# XRAY M18T

## TECH TIP: MODIFICATION OF SERVO HOLDERS

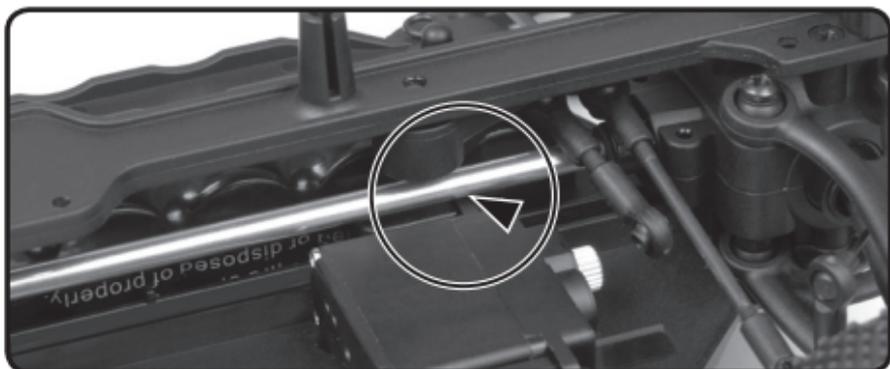
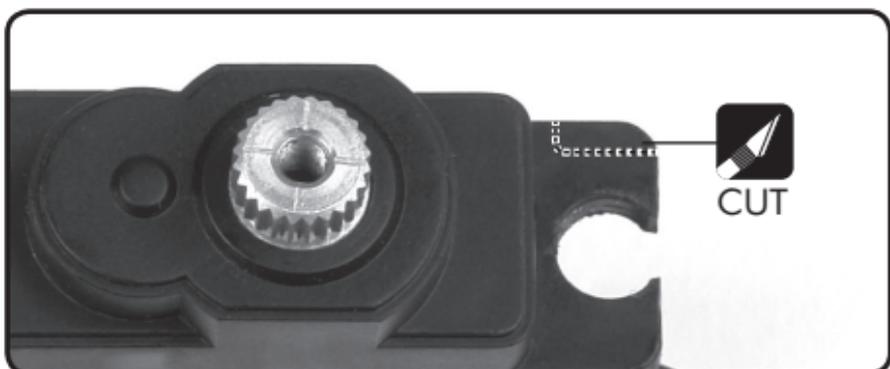
Some servos may get into contact with the central aluminum layshaft and this can brake the free action of the transmission. It is suggested to slightly modify the holder of the servo.

Use a sharp hobby knife and remove the edge of the servo holder as shown.

View on the finished modification
